ADDENDUM
NO. 3

April 17, 2026

**TRI-TOWNSHIP WANATAH SCHOOL
RENOVATION AND RELATED WORK
Wanatah, IN 46390**

This Addendum consists of Pages ADD 3-1 through ADD 3-4, and attached Addendum No. 3 from Gibraltar Design dated April 16, 2026 and consisting of 5 pages, replacement Specification Section 33 40 00 - Storm Sewage Systems, and 15 drawings.

GIBRALTAR DESIGN SHEET
B A-311

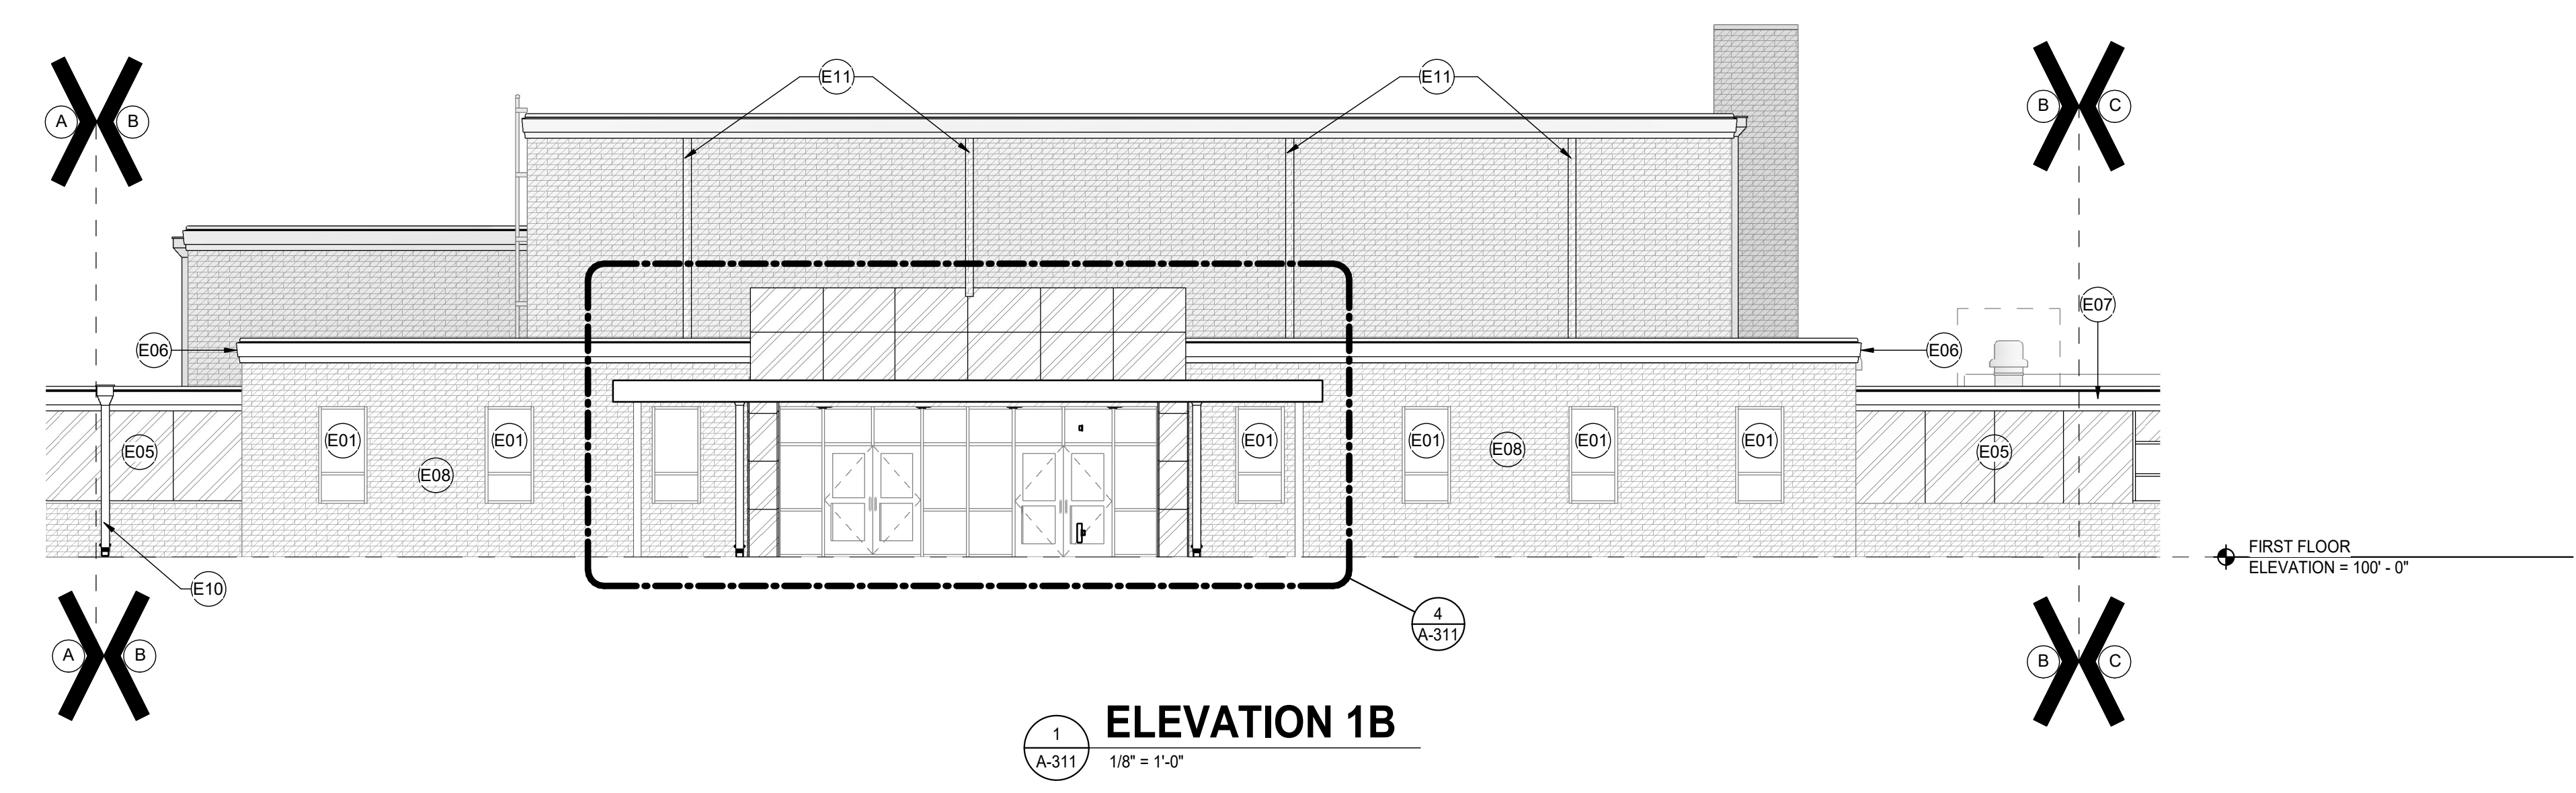
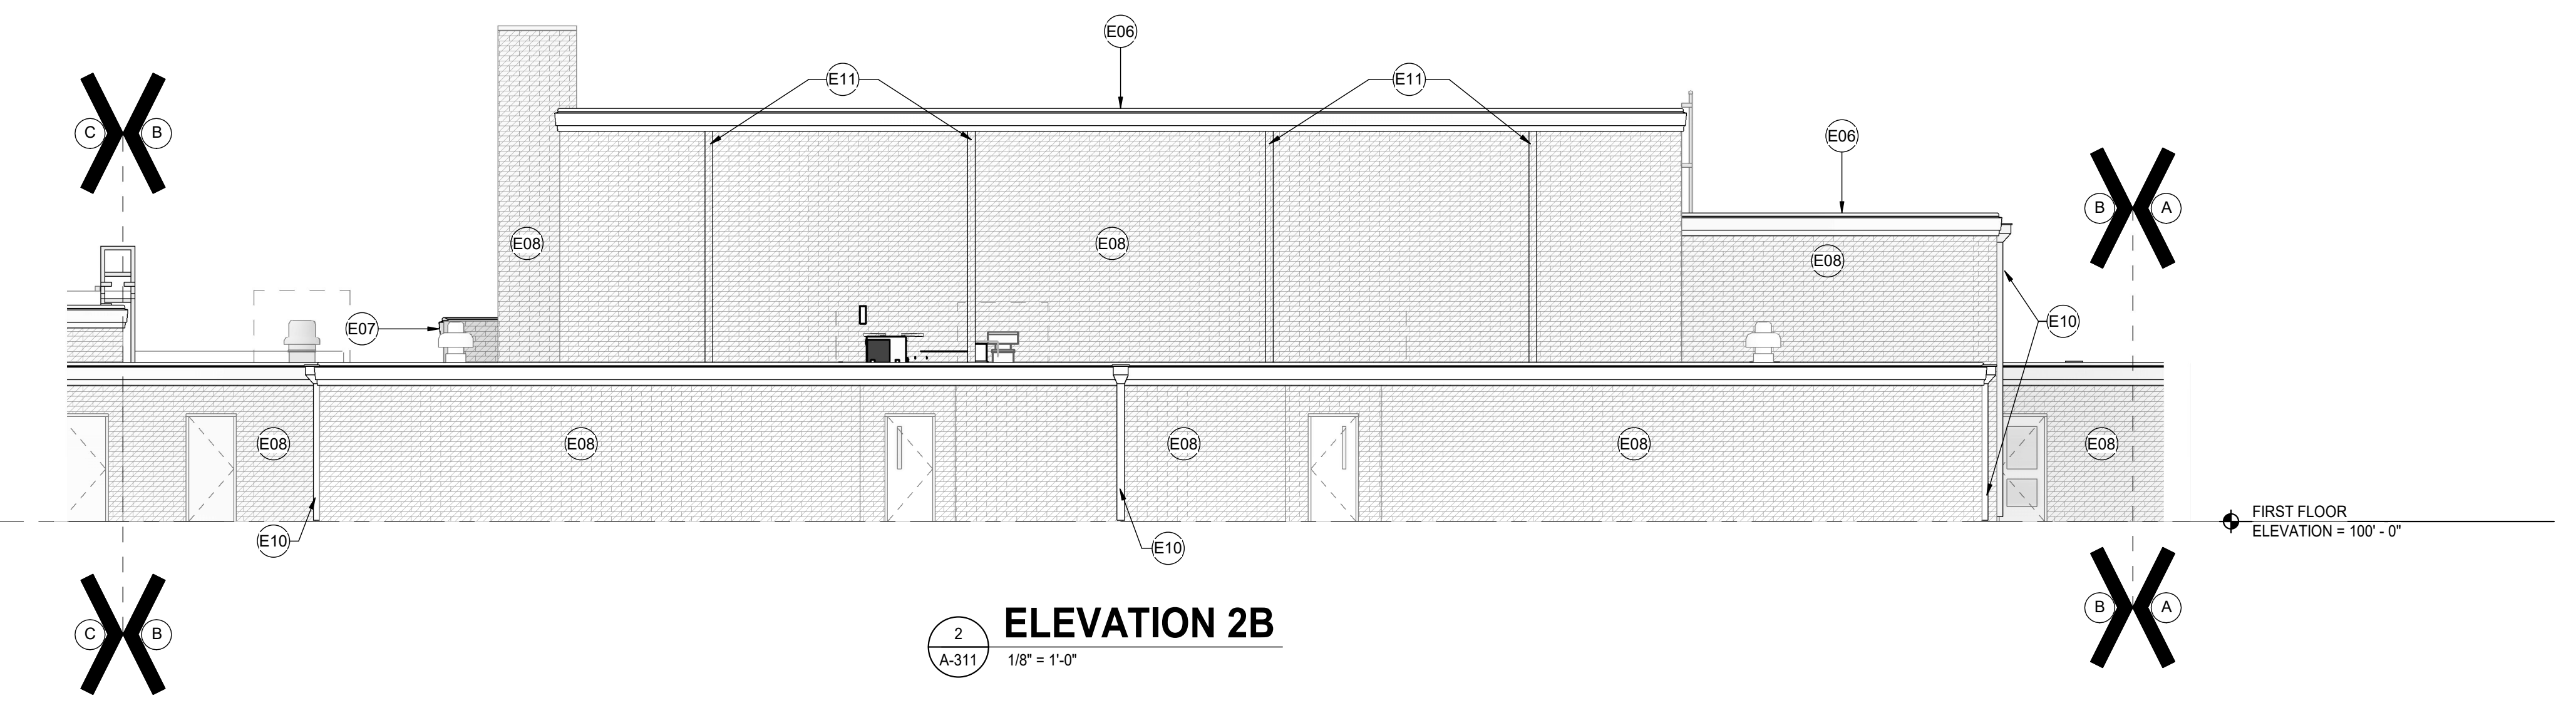
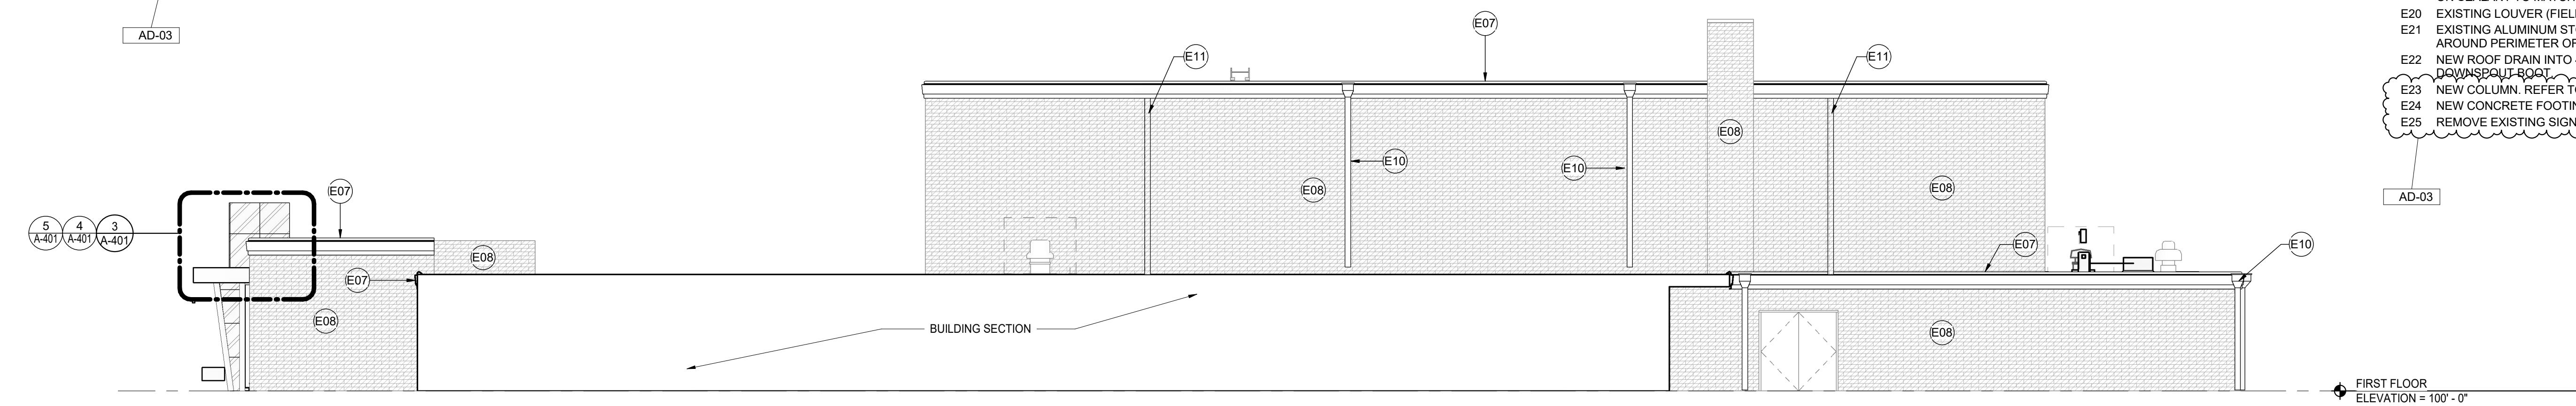
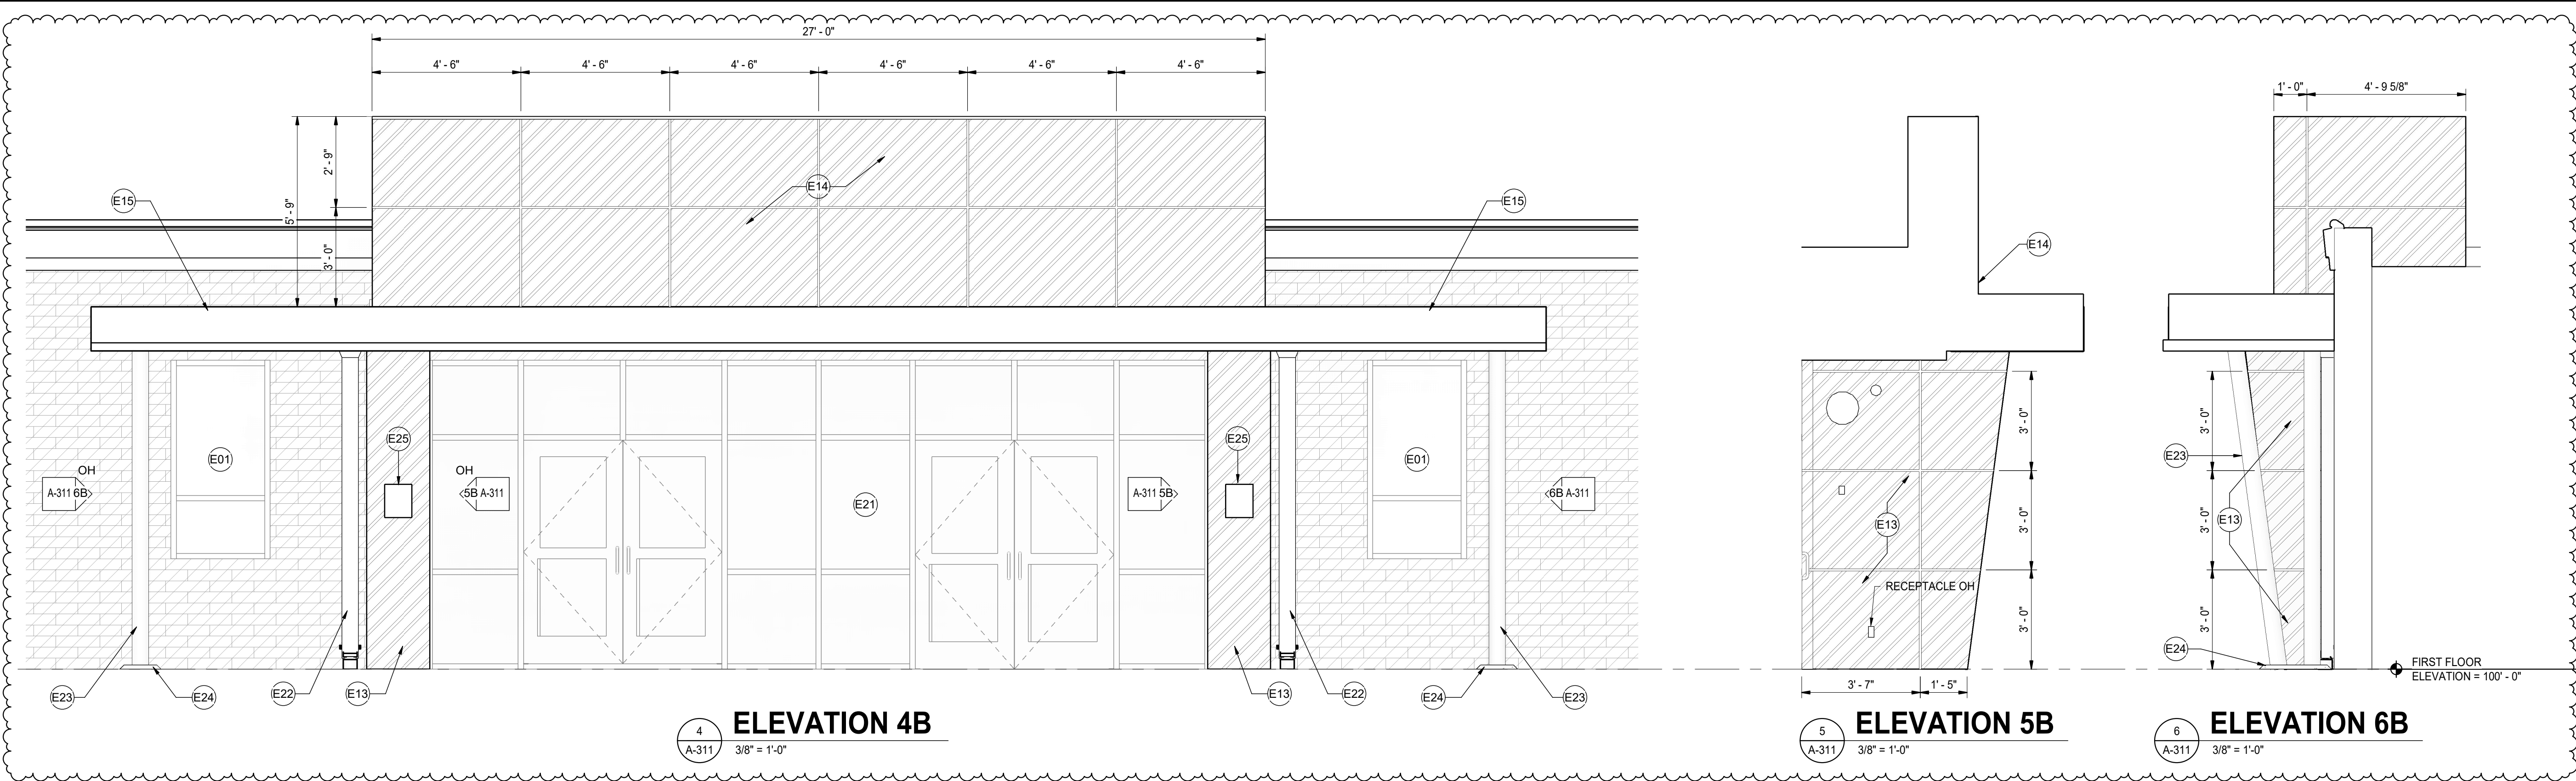
20. Sheet A-311

- A. Refer to revised, full-size drawing, for additional elevation of canopy clarification, included in this Addendum.

1 ELECTRICAL SITE DEMOLITION PLAN
ES101 1" = 50'-0"

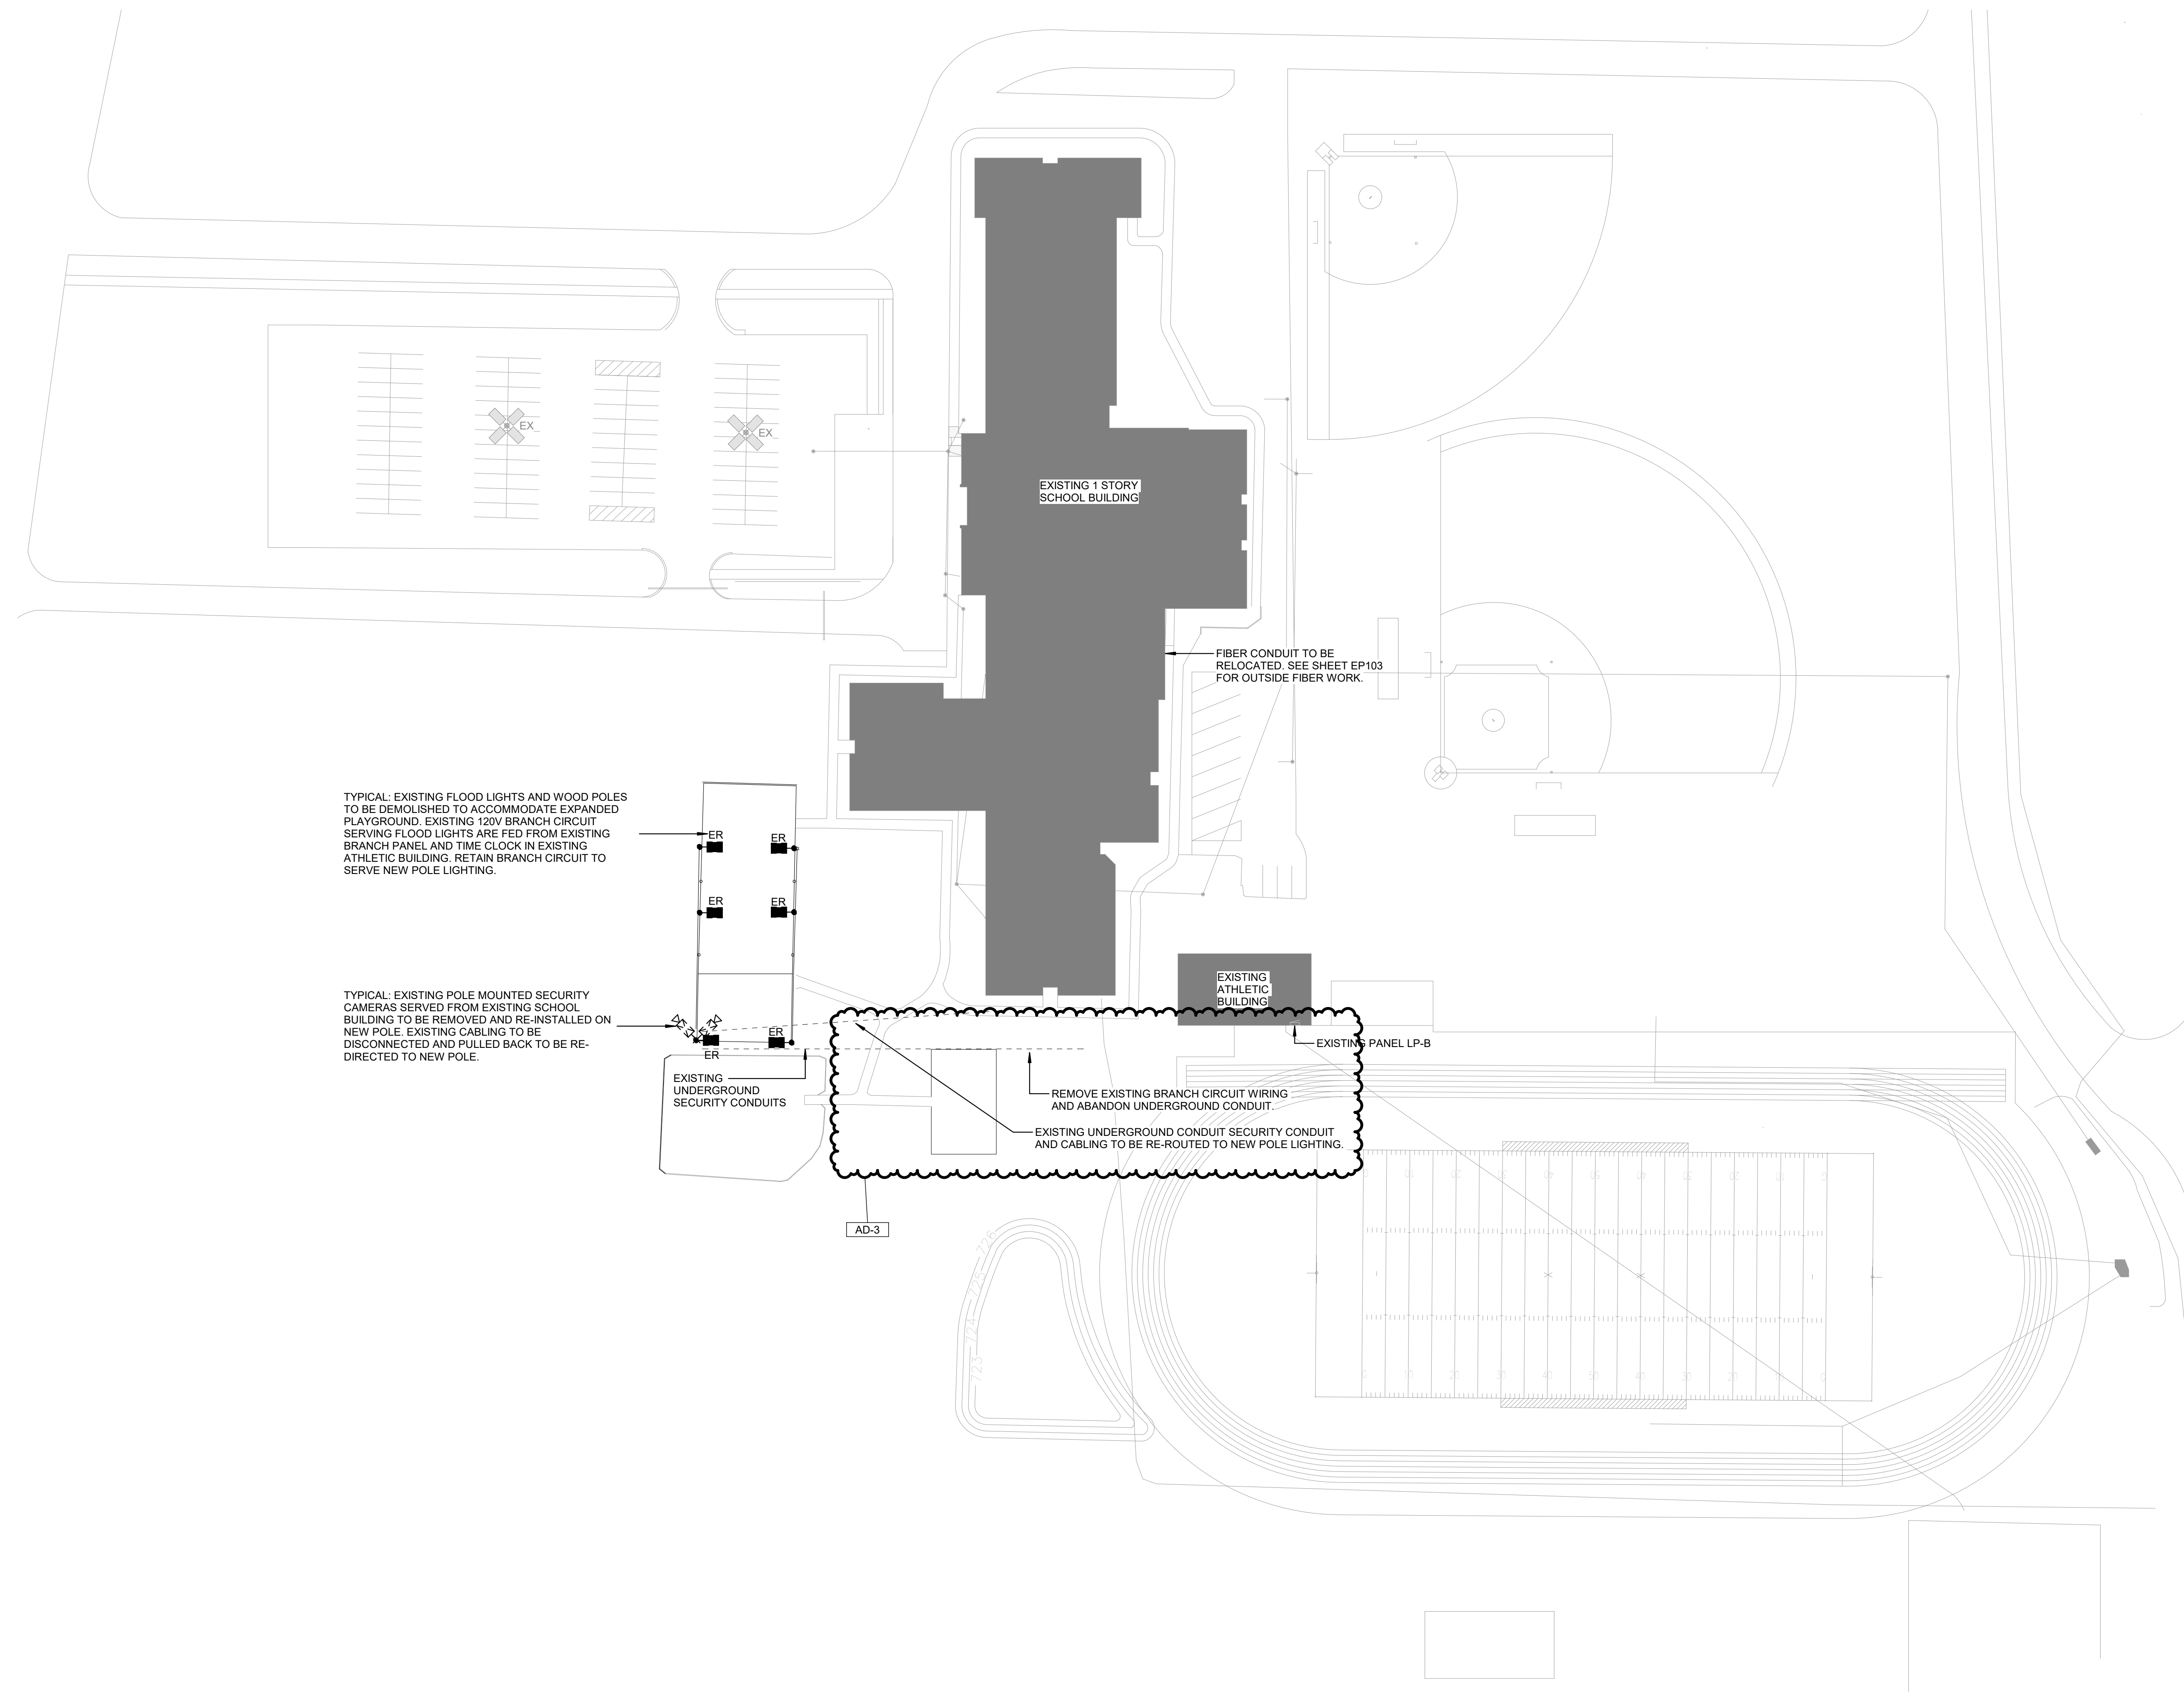
23. Sheet ES-101

- A. Refer to revised, full-size drawing, for Branch Circuit requirements to New Playground
